BOWMANS CREEK **WIND FARM**
Response to Additional Information Request

Bowmans Creek Wind Farm LVIA (SSD-10315) response to DPIE request for additional information

Additional Information for Visual Assessment:

Cross Section G17-1 – T59 location plan

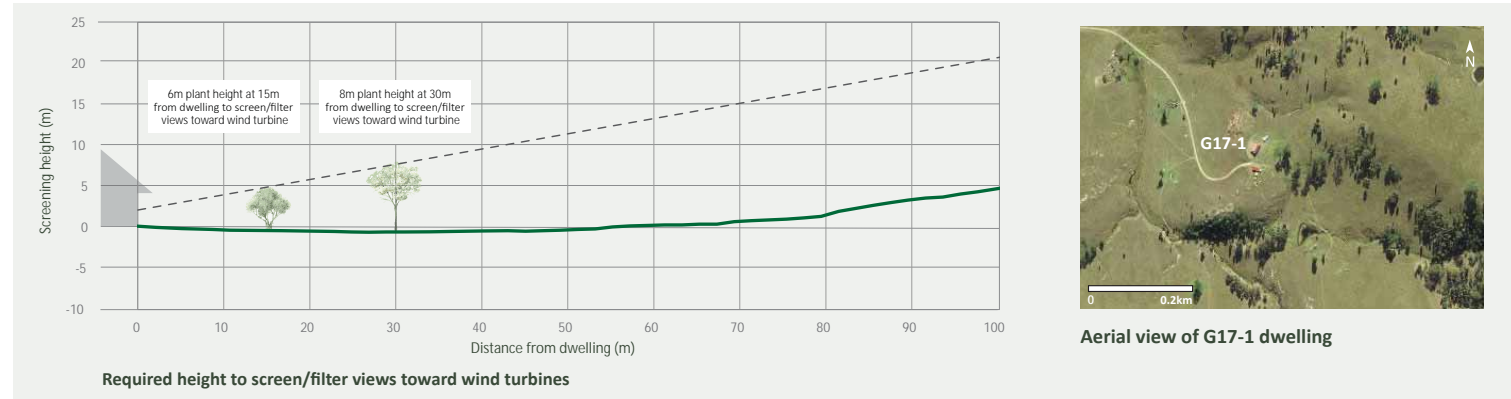
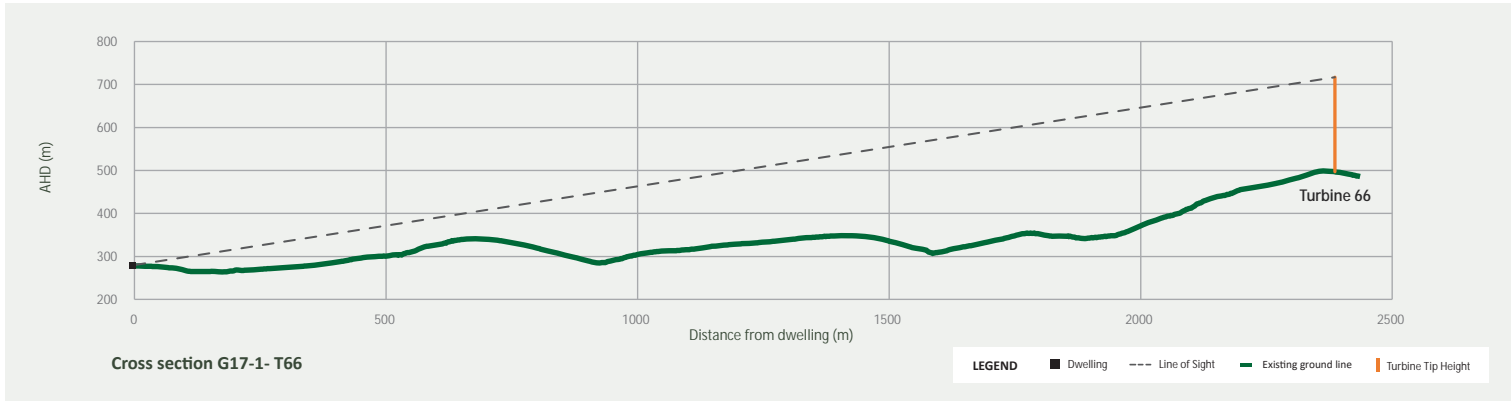
Photomontage prepared from dwelling G17-1 illustrates direct and open views toward 4 turbines on an elevated ridgeline east of dwelling G17-1. Existing mature eucalypt trees beyond the dwelling screen/filter views toward other turbines on the ridgeline. A cross section analysis has determined that screen planting between 7m to 8m in height at 30m from the dwelling would provide screening toward wind turbines.

Without screening, the turbines would have potential to result in a significant visual impact at dwelling G17-1. With screening the wind turbines would not have a significant visual impact at dwelling G17-1.

Cross Section H12-3 – T36 location plan

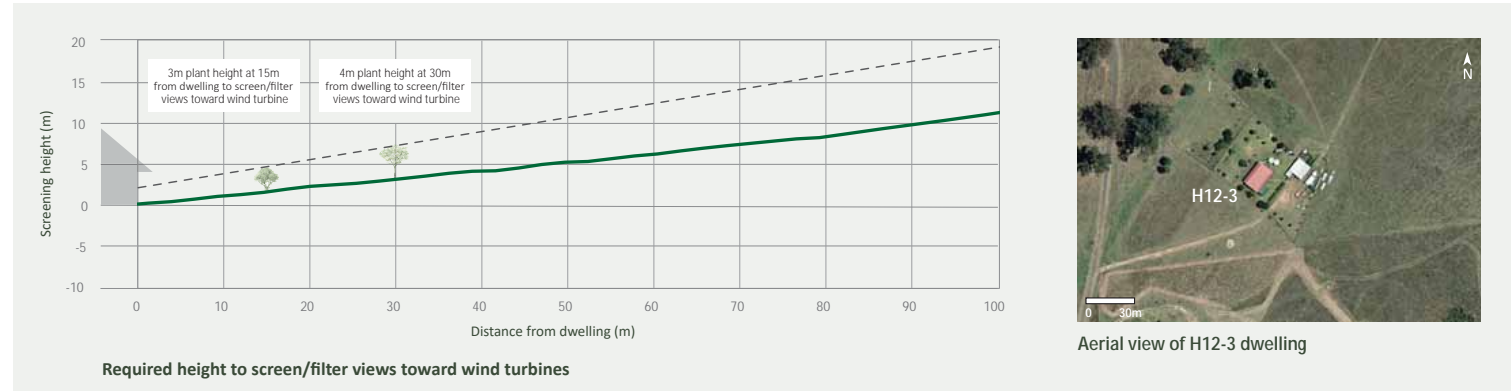
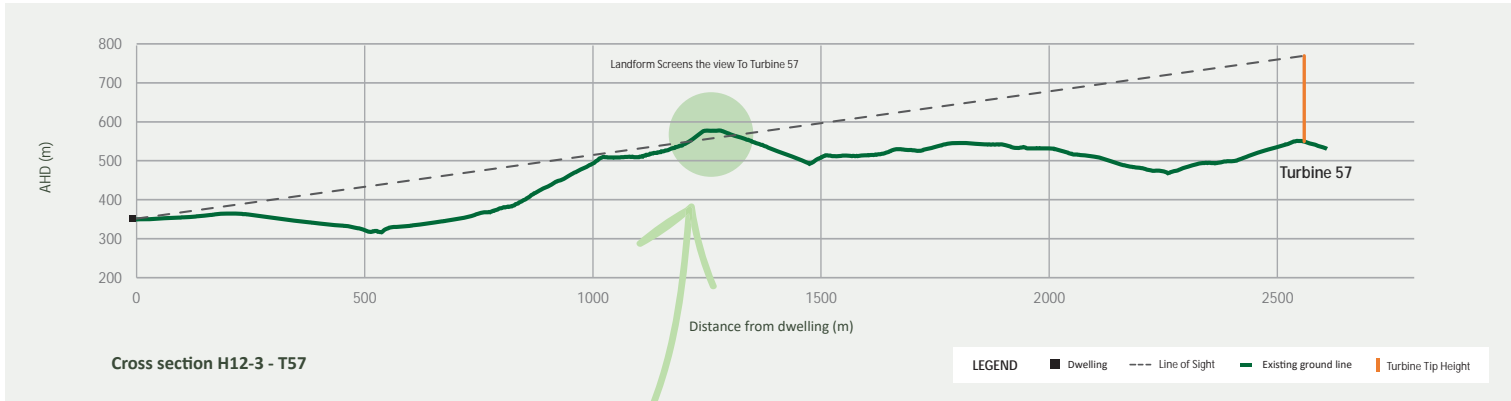
Views from the dwellings would extend toward a small number of turbines within the north west portion of the project site. A cross section analysis has determined that screen planting 4m in height at 30m from the dwelling would provide screening toward wind turbines.

Without screening, the wind turbines would not result in a significant visual impact at dwelling H12-3, H12-2 and H11-1.

Cross Section T6-2– T12 location plan

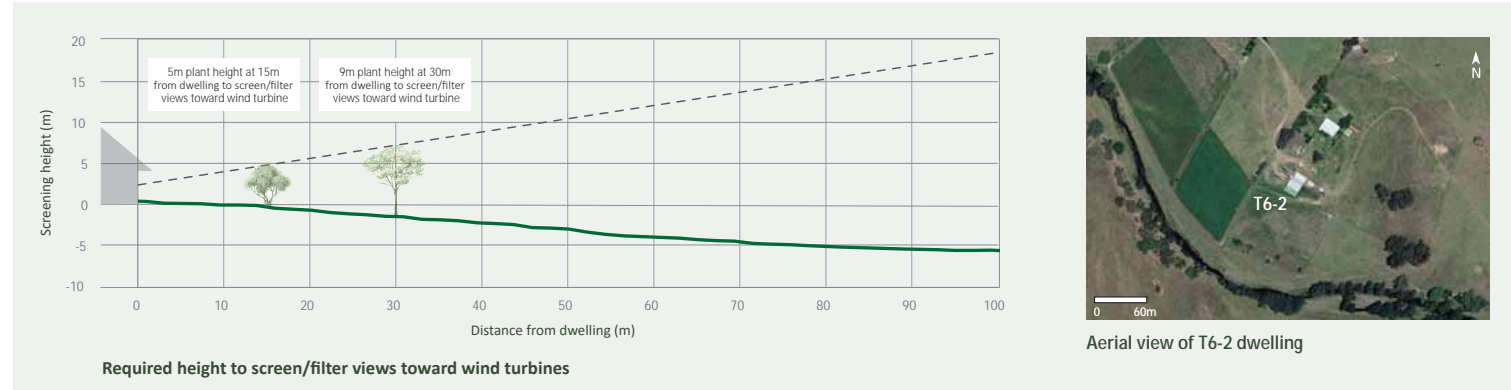
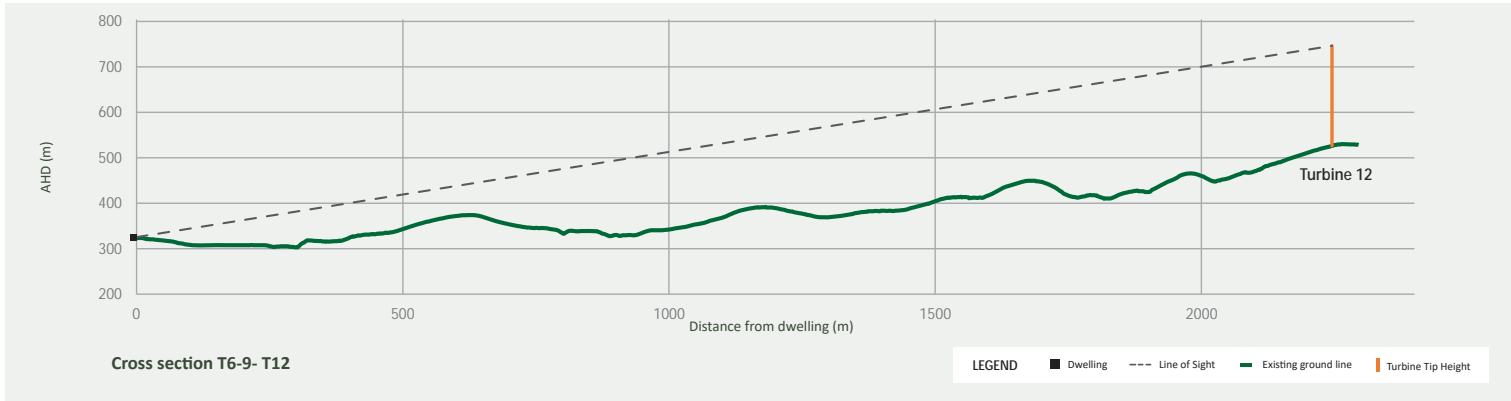
Residual impacts: The photomontage prepared for dwelling T6-2 illustrates that a clustered group of turbines would be visible above an existing shed. Spot planting of trees between the farm shed and the dwelling would provide some degree of screening toward the turbines over time. However, tree planting may result in shading of solar panels on the shed, or upon the vegetable garden between the shed and dwelling. A cross section analysis has determined that screen planting around 9m in height at 30m from the dwelling would provide screening toward wind turbines.

Visual significance: Without screening, the wind turbines would not result in a significant visual impact at dwelling T6-2.

Cross Section V20-1 – T7 location plan

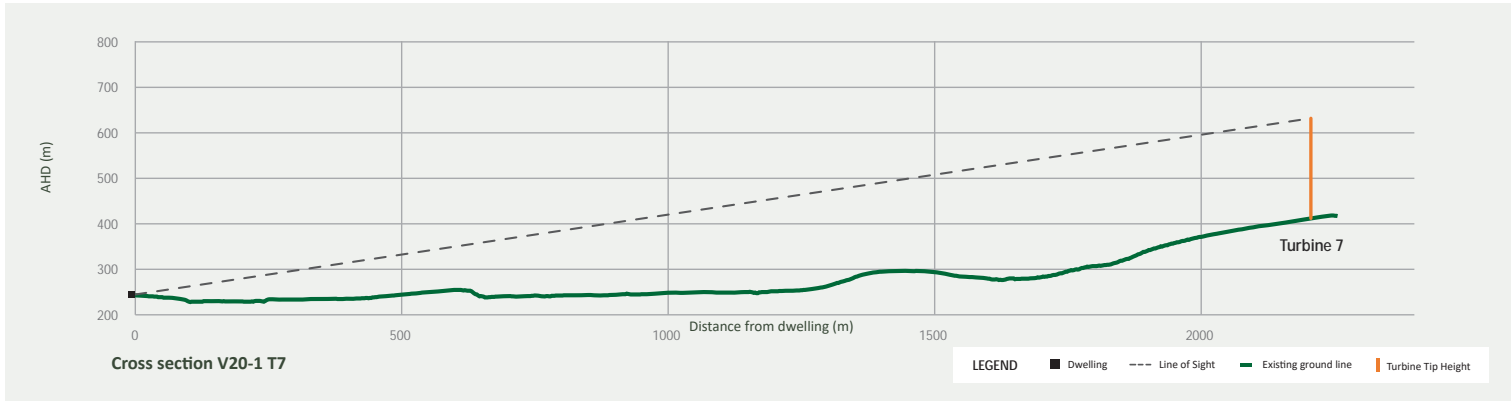
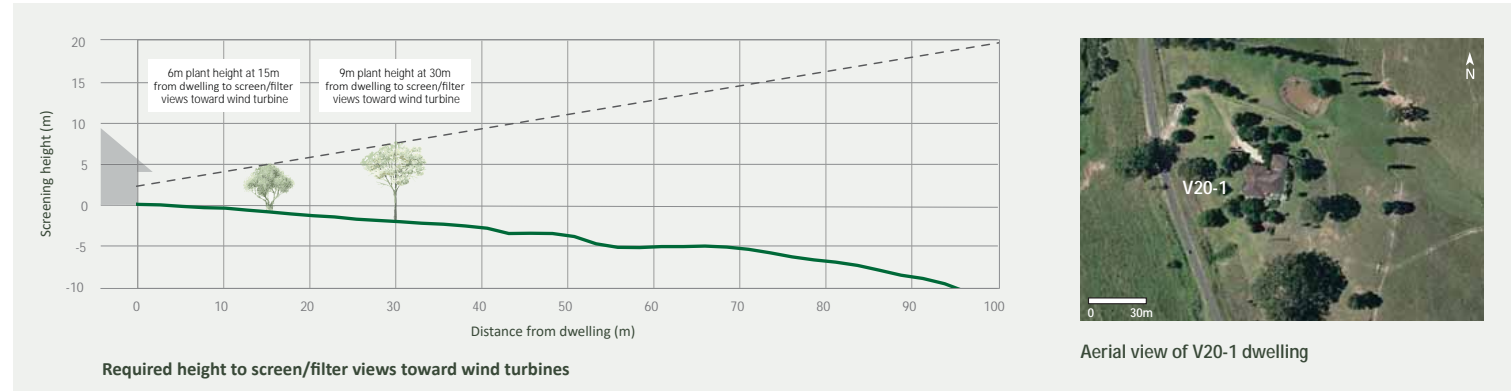
Residual impacts
Landform and tree cover beyond the dwelling will screen views toward most wind turbines from the dwelling and from various locations from the dwelling curtilage. A cross section analysis has determined that screen planting around 9m in height at 30m from the dwelling would provide screening toward wind turbines.
